Subject: Transmittal of P-5 and P-6  
Solid Waste Permit LF-0001-08  
West Hawaii Sanitary Landfill

Subject: Geosyntec Consultants Response to DOH Permit Renewal Application Comments  
Solid Waste Management Permit No. LF-0001-08  
West Hawaii Sanitary Landfill

**Subject: Response to Permit Renewal Application Comments  
Solid Waste Management Permit No. LF-0001-08  
West Hawaii Sanitary Landfill**

Subject: Response to Permit Renewal Application Comments  
Solid Waste Management Permit No. LF-0001-08  
West Hawaii Sanitary Landfill

Title: Section A\_A'  
 Comments: West Hawaii- Cell 9A (remainder) & Cell 10A (partial)  
 Name: A\_A' (As-Built)\_to EL202ft\_REV.gsz  
 Date: 4/4/2012

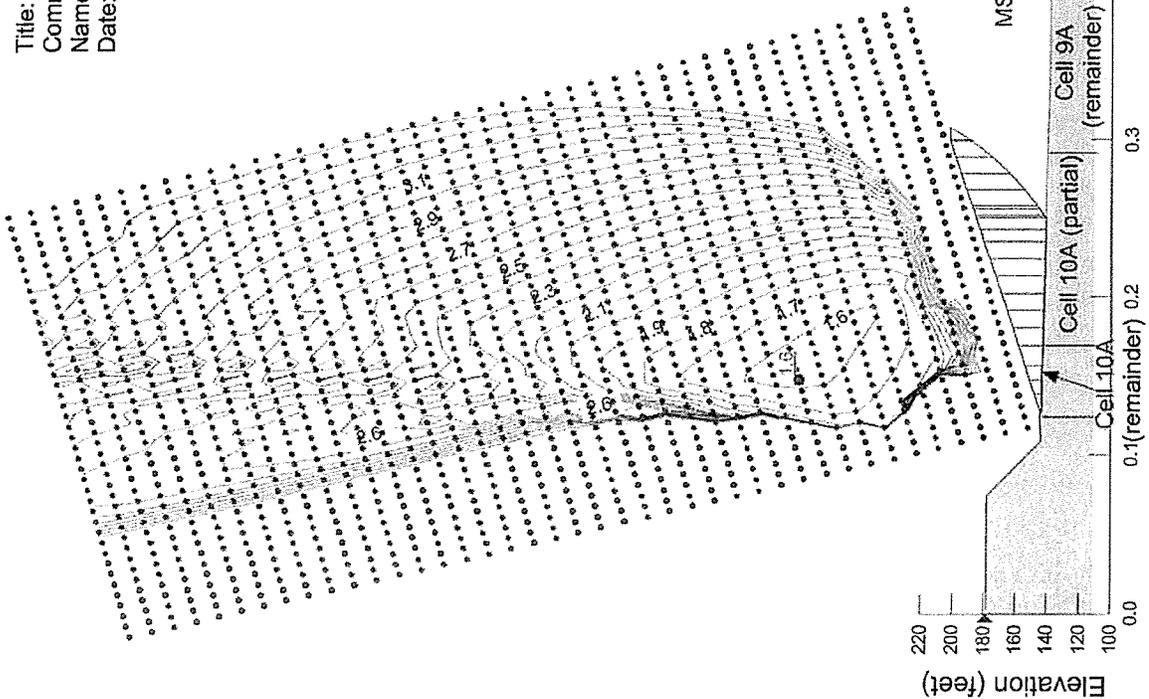
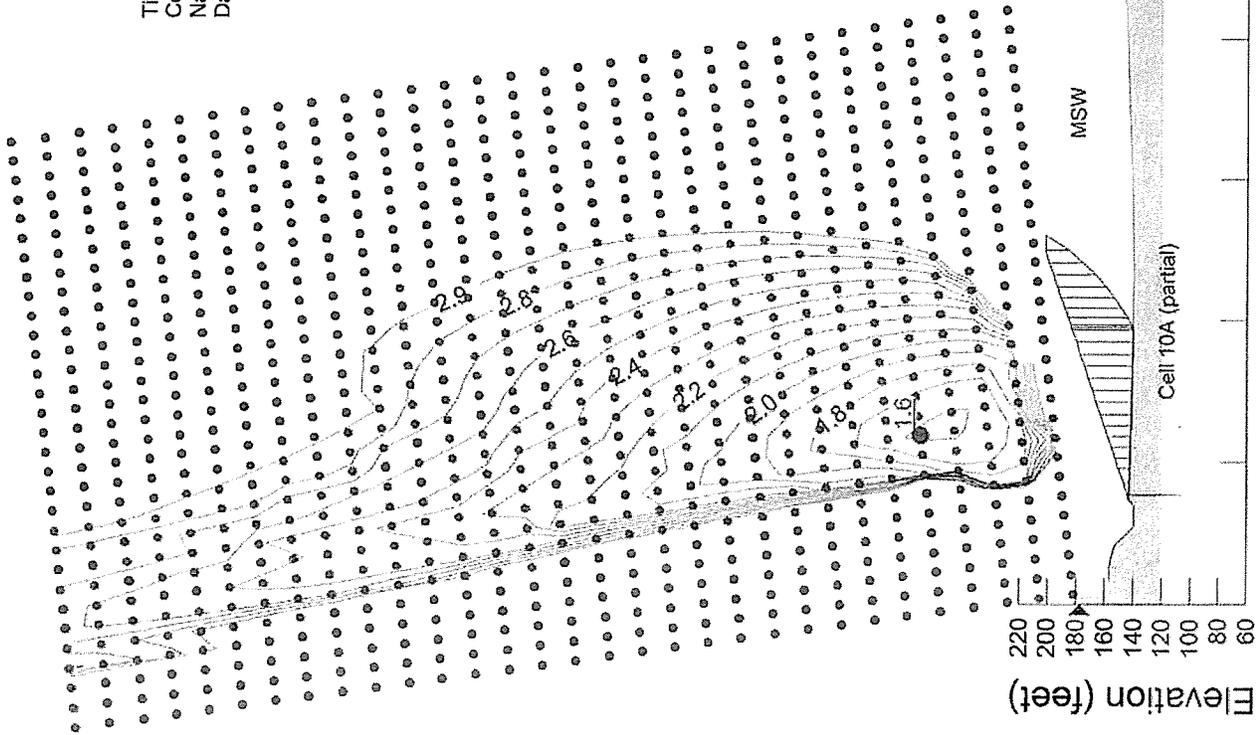
8A Remainder and 9A. Submit a revised analysis to reflect actual materials used in the construction.

- b. Provide the basis for determining the  $F_n$  values used in each slope stability analysis. For example, in Cell 2, the  $F_n$  value is listed as  $F_n=1$ , for the analysis of Cell 10A (remainder) and 11A (partial), but is listed as  $F_n=3$  for the analysis of Cell 9A (remainder) and 10A (partial).

**As-built interface strength data for the Cells 1 and 2 liner systems are not available. At the time of the 4 June 2010 report, Geosyntec assumed an interface strength for Cells 1 and 2. However, since that time, Geosyntec has developed an assumed conservative strength envelope for evaluation of the liners for Cells 1 through 7 based on information available in the literature and on our experience with similar materials. The envelope is shown below for Part b. The analyses from the 4 June 2010 report have been revised with this conservative envelope for consistency, and are provided herein.**

| DEPARTMENT OF ENVIRONMENTAL MANAGEMENT<br>SOLID WASTE DIVISION<br>SITE IMPROVEMENTS FOR THE<br>WEST HAWAII RESOURCE<br>RECOVERY INFRASTRUCTURE<br>GENERAL SITE PLAN |  | SHEET: SW-3755<br>OF: 3                           |  |

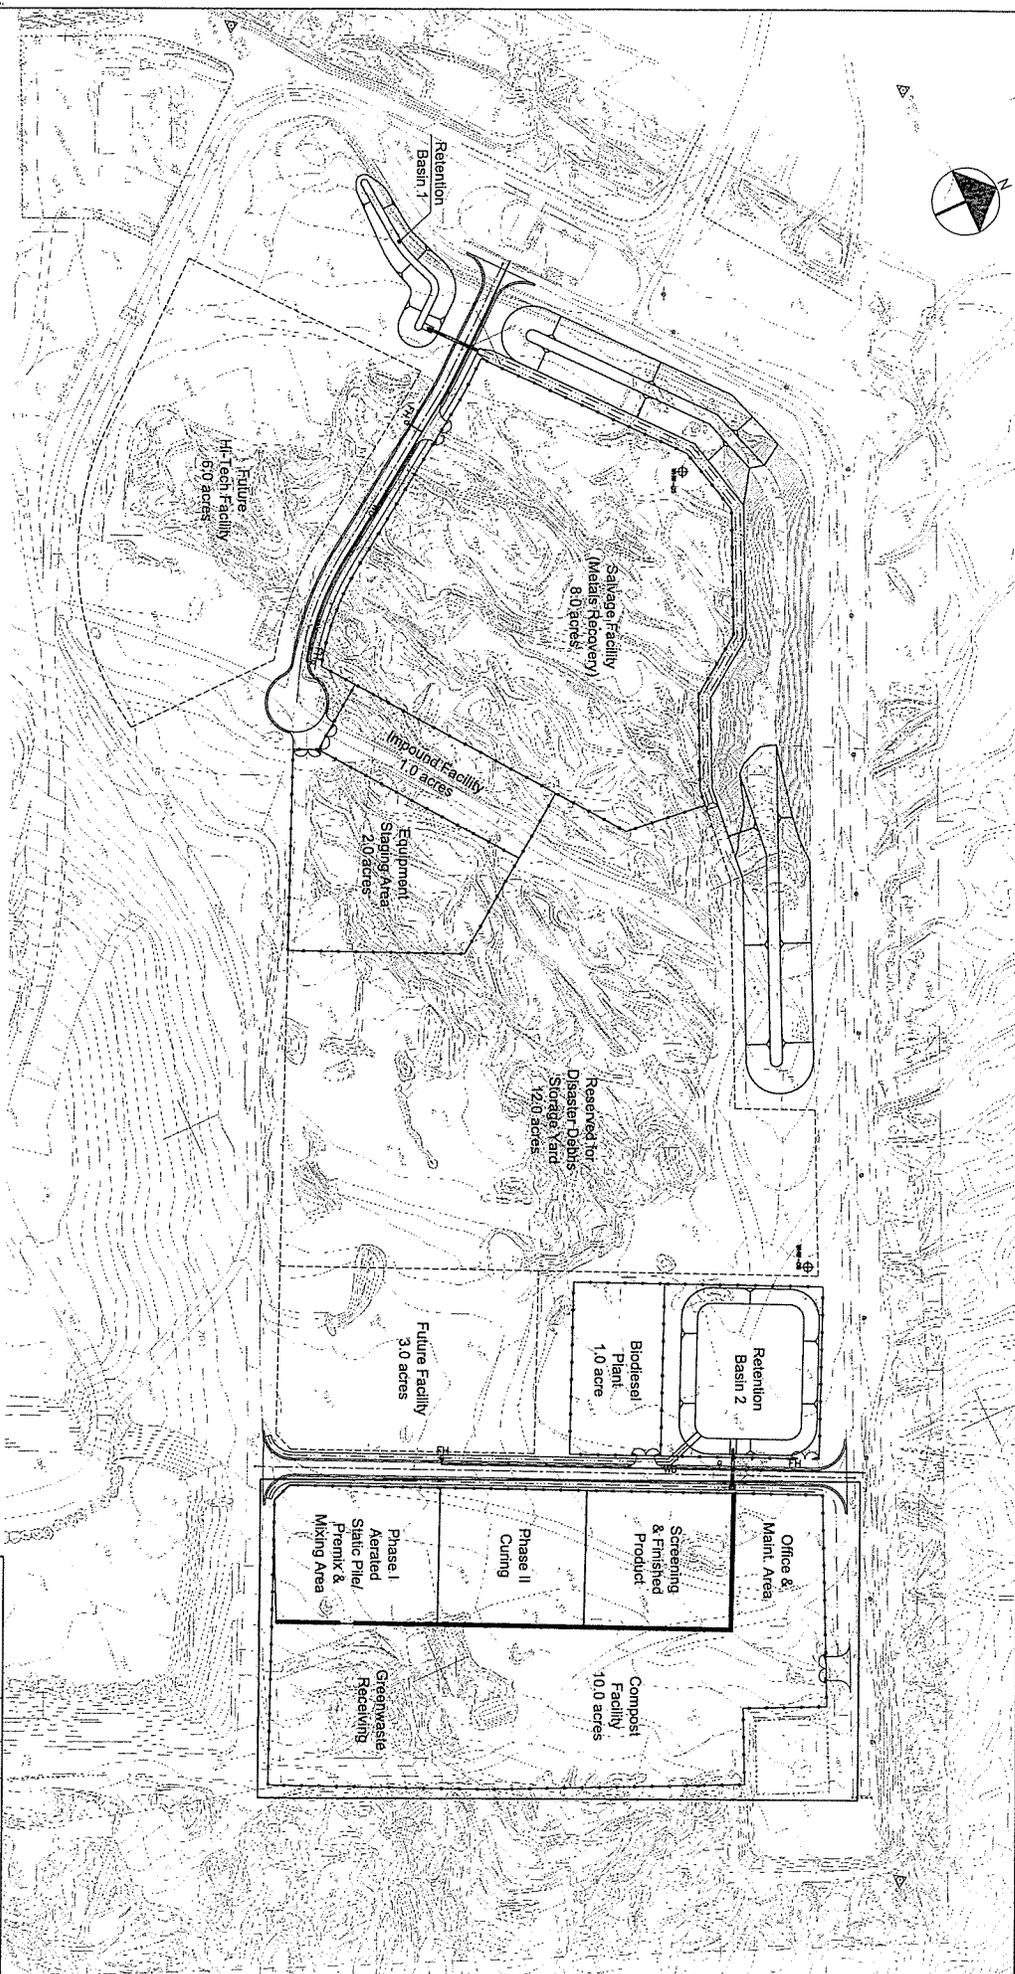
**Comment 1. Provide an updated site plan, showing the location of the other proposed County operations at the site.**

**Response to Comment 1:** The County of Hawaii has provided an updated site plan, which is attached hereto.

Title: SECTION A3 - WEST SLOPE, PERMIT BG  
 Description: WEST HAWAII - MASTER PLAN  
 File Name: A3\_West Slope-Permit BG.gsz  
 Date: 5/29/2012  
 Method: Spencer  
 Horz Seismic Load: 0g

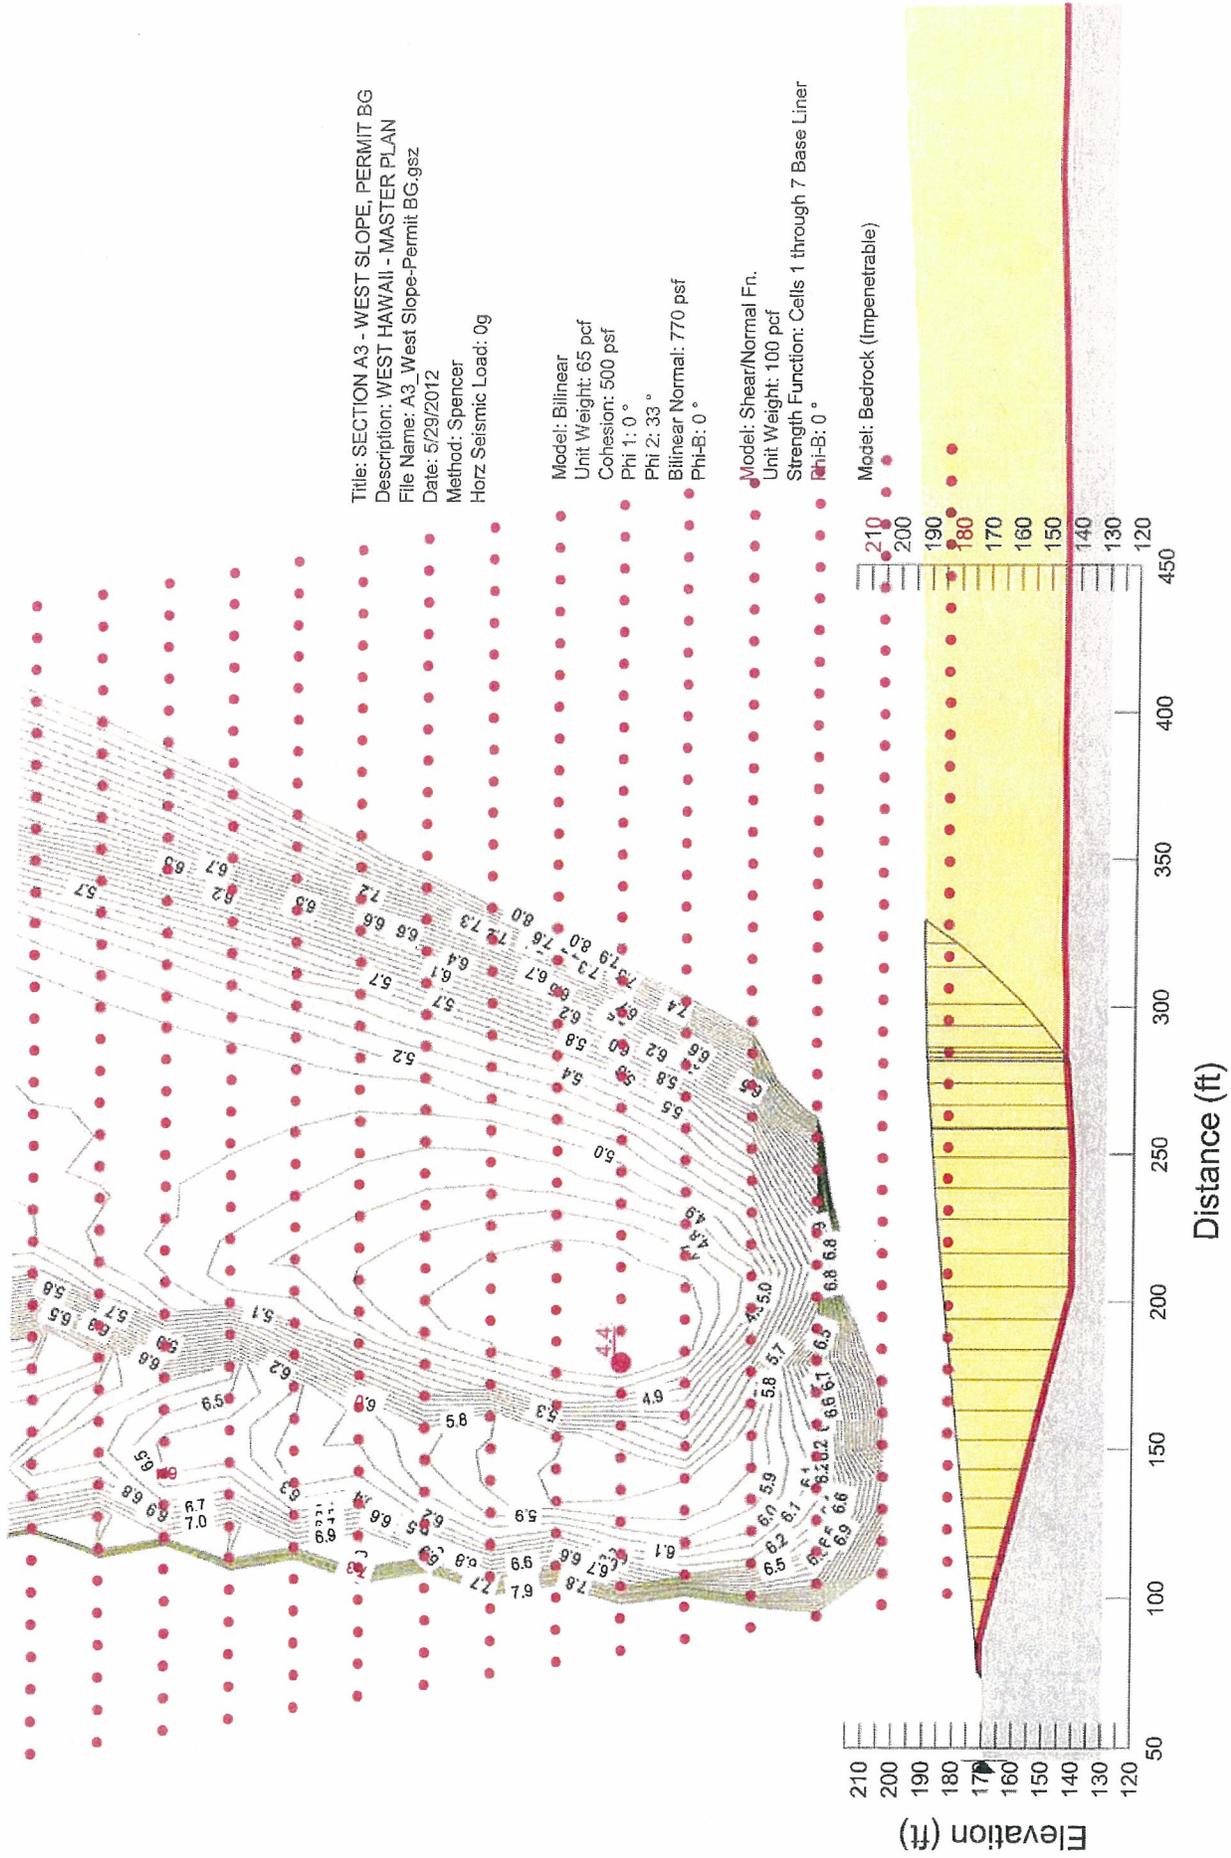
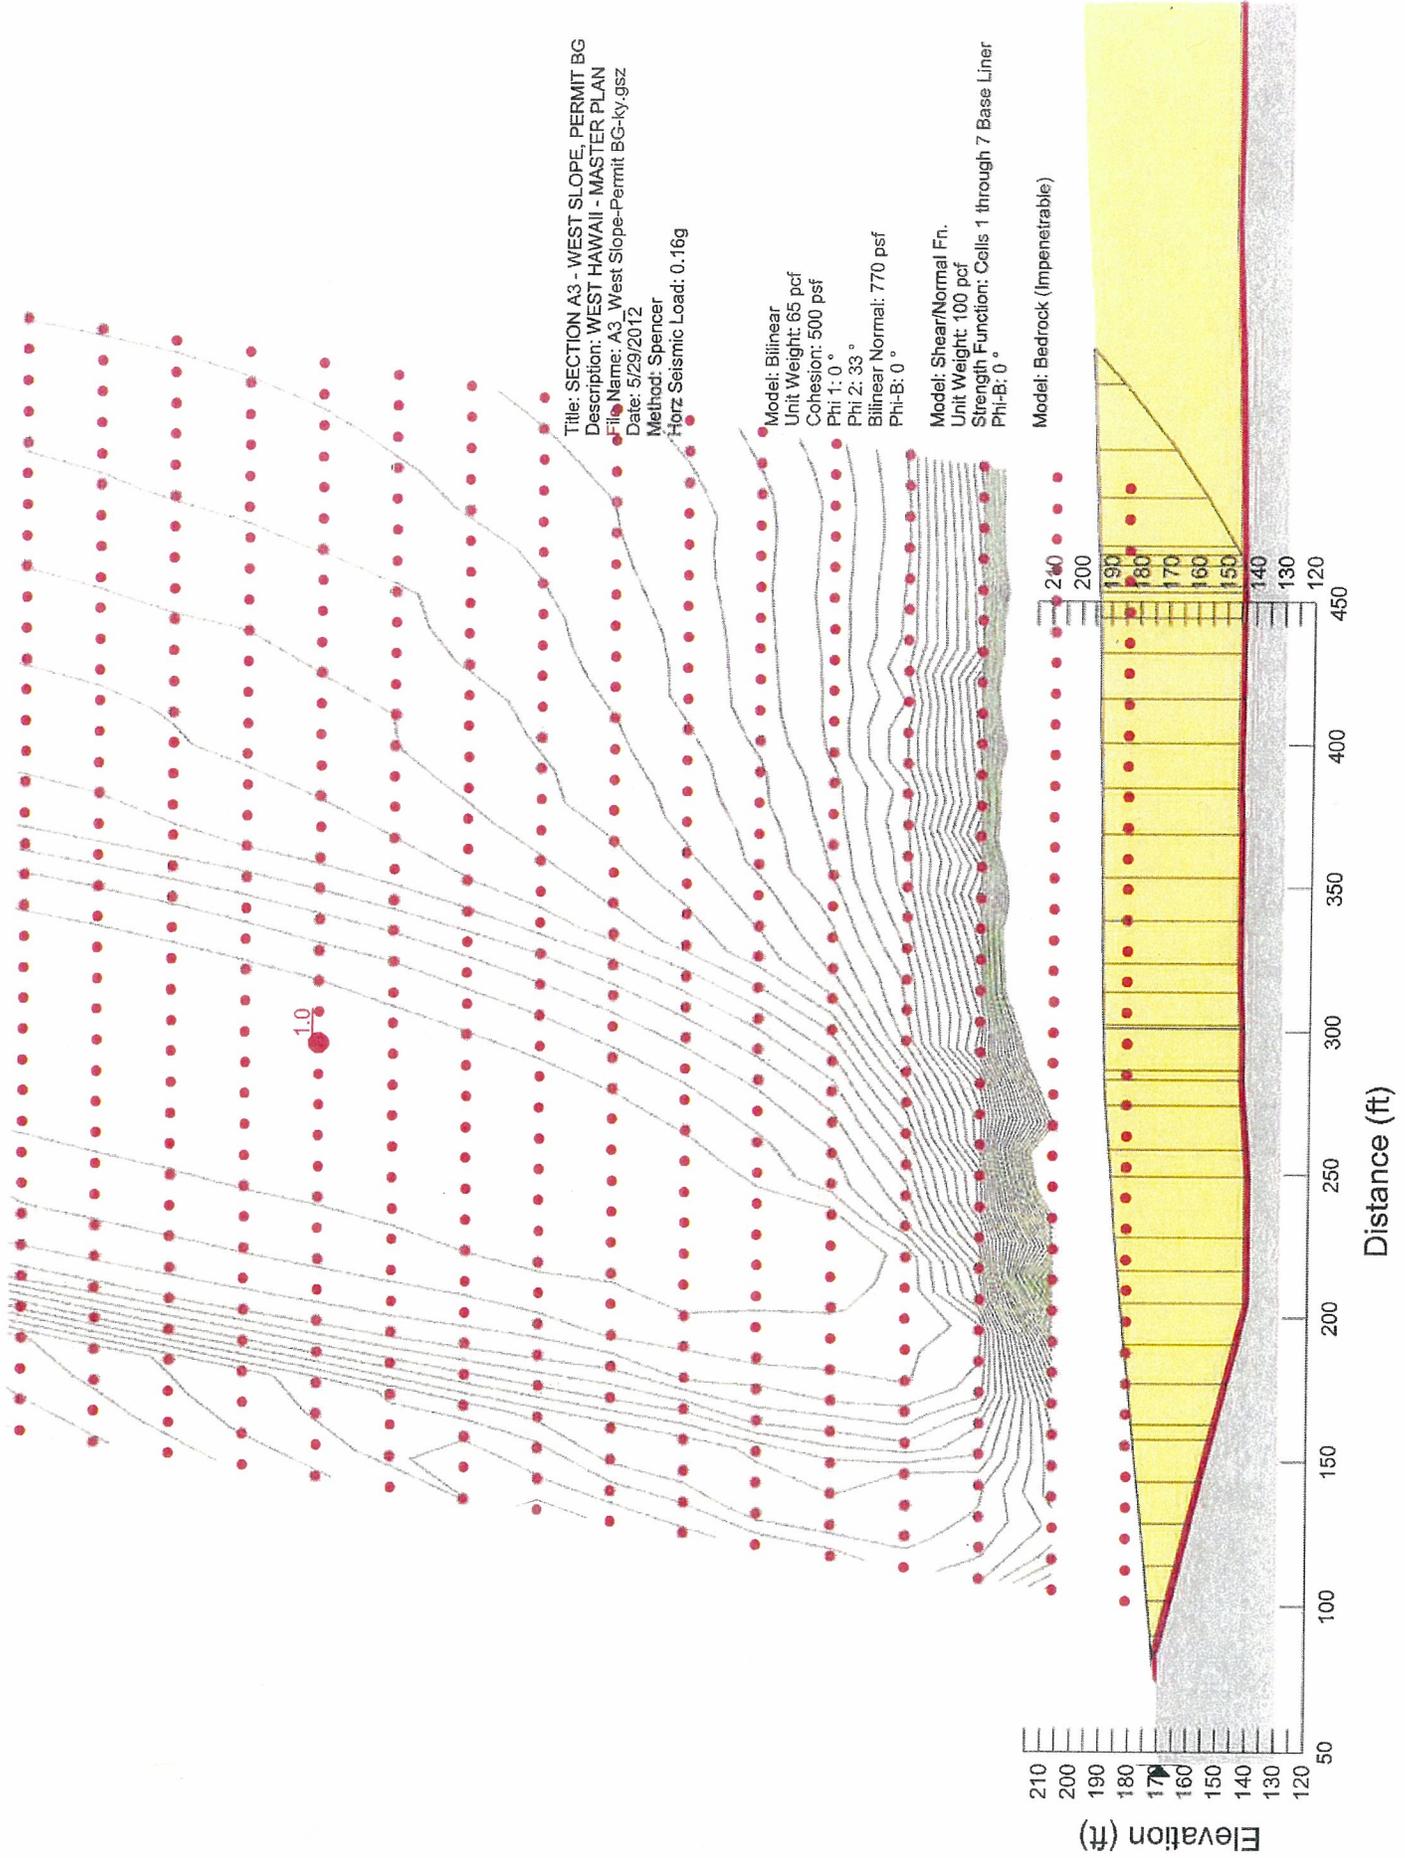
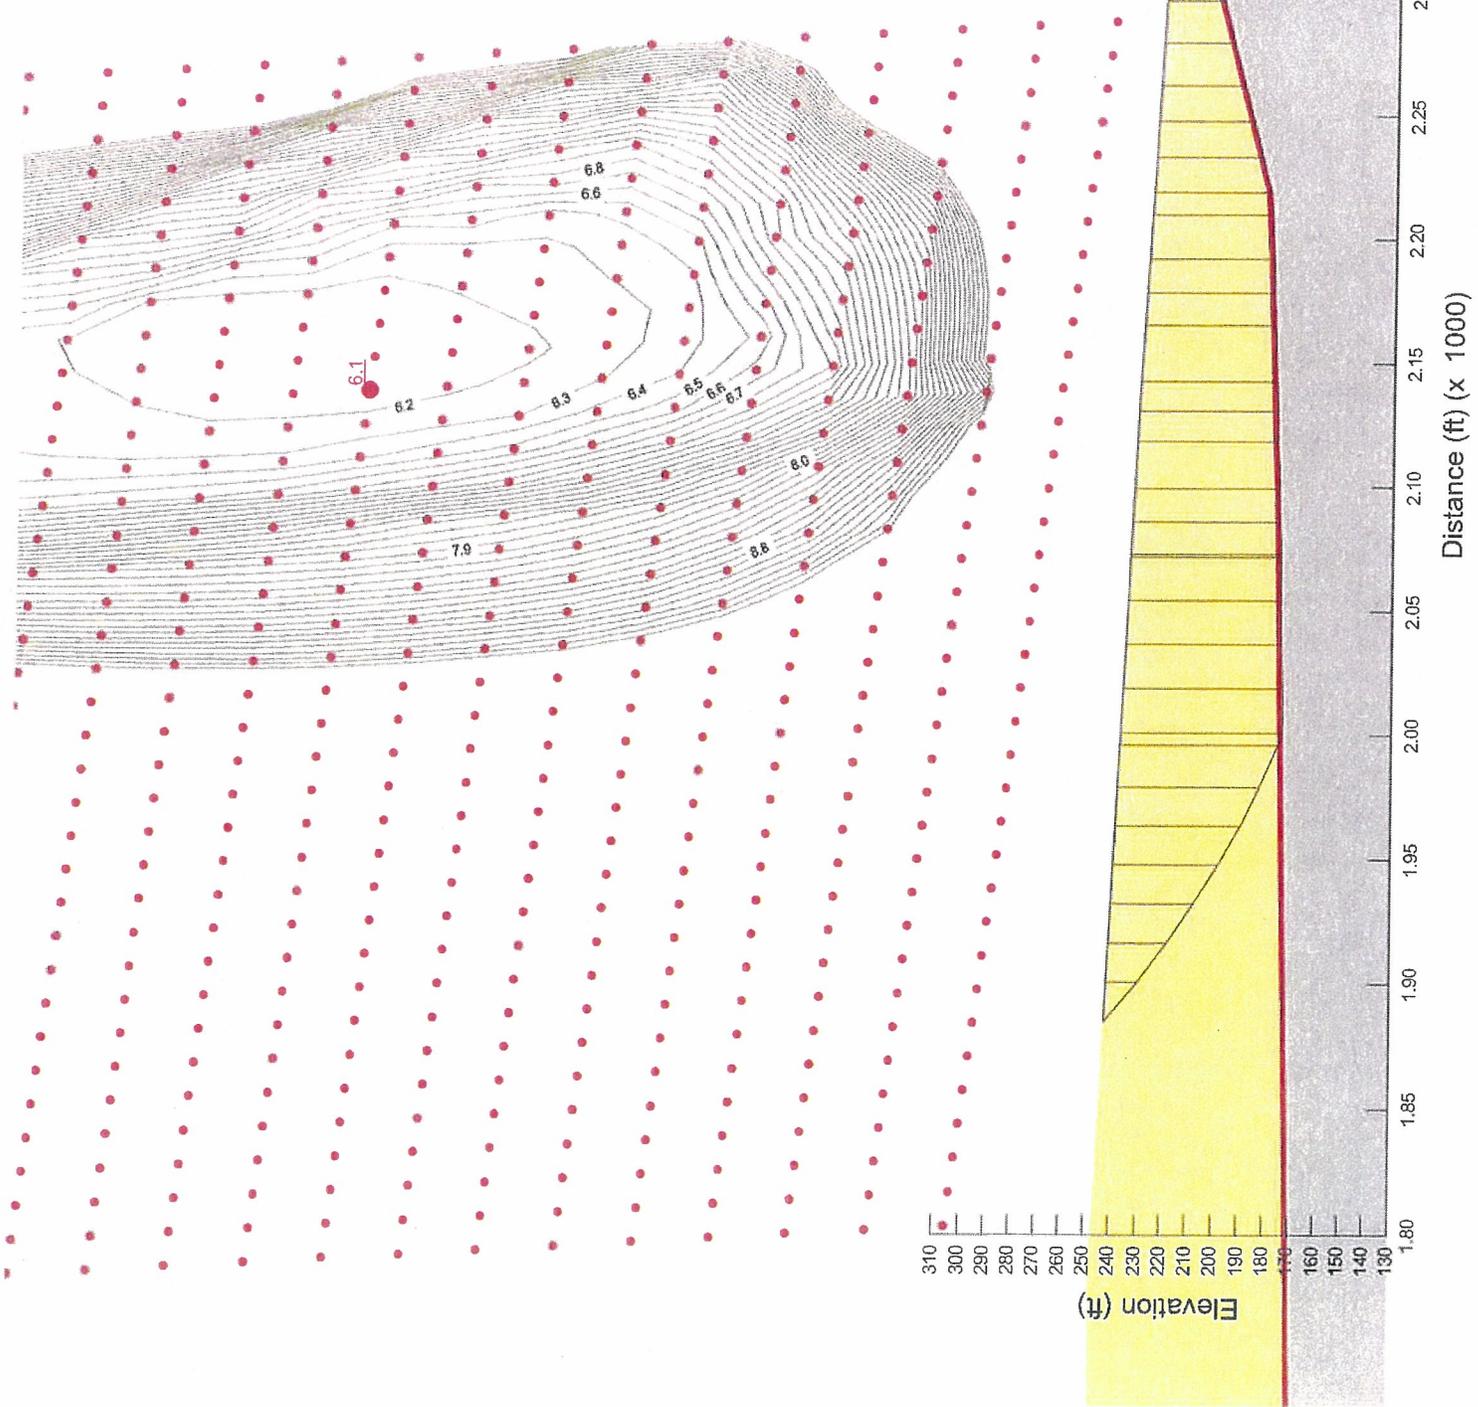
**Response to Item 5.a. Your Master Plan Report of March 2012 includes slope stability analyses for cross sections through Cells 8-15 and Cells 16-23. Please also evaluate and include a slope stability analysis for a cross section through Cells 1-7.**

Using the existing permitted base grades and the revised final grades as per the 12 March 2012 *Master Plan Report*, the landfill slopes are stable.
